**ADDENDUM NO. 7**

October 16, 2024

**CORNER CANYON HS FIELD HOUSE**

12943 South 700 East  
DRAPER UT, 84020

SHEET NUMBER  
**LS101**

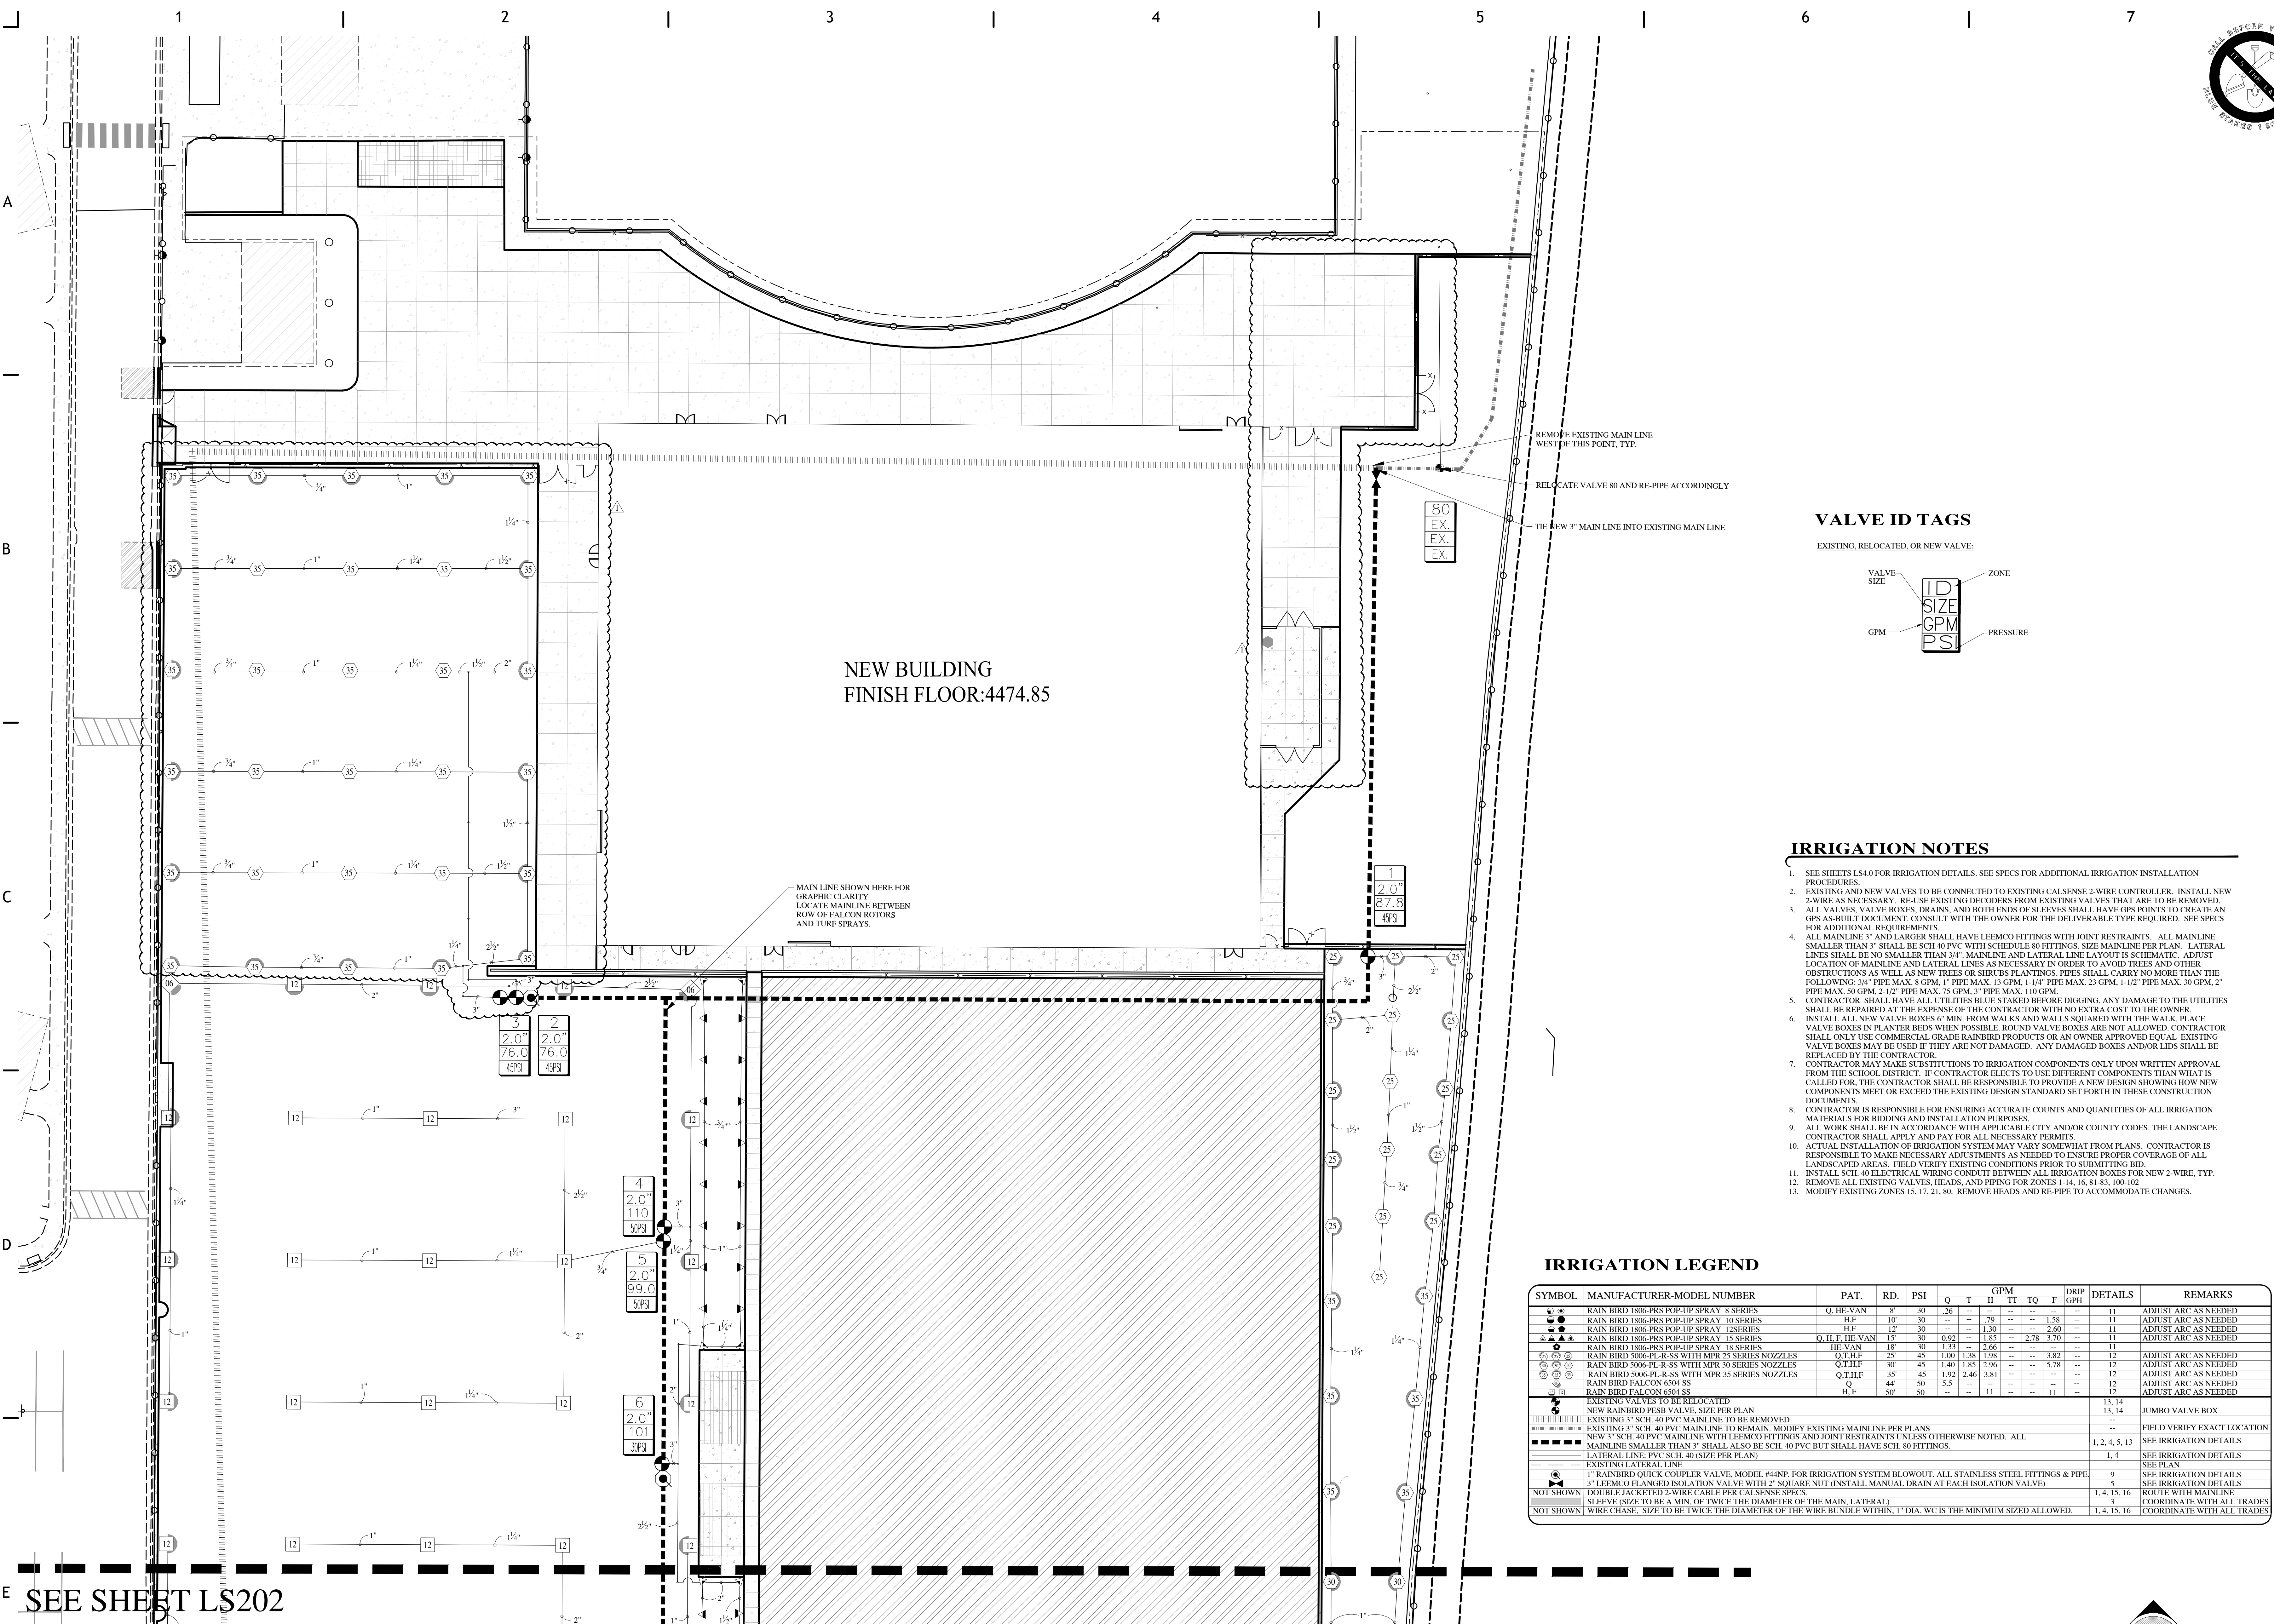
The fire marshal has requested the added fire truck access on the east and west sides of the fieldhouse. Changes are as follows:

1. The concrete sidewalk on the west was widened and the lawn area reduced.
2. The concrete sidewalk and plaza on the east side was widened and rock mulch area was reduced.
3. A double swing gate was added to the east and west side of the fieldhouse.
4. Irrigation zones 2 and 3 were adjusted and re-piped.
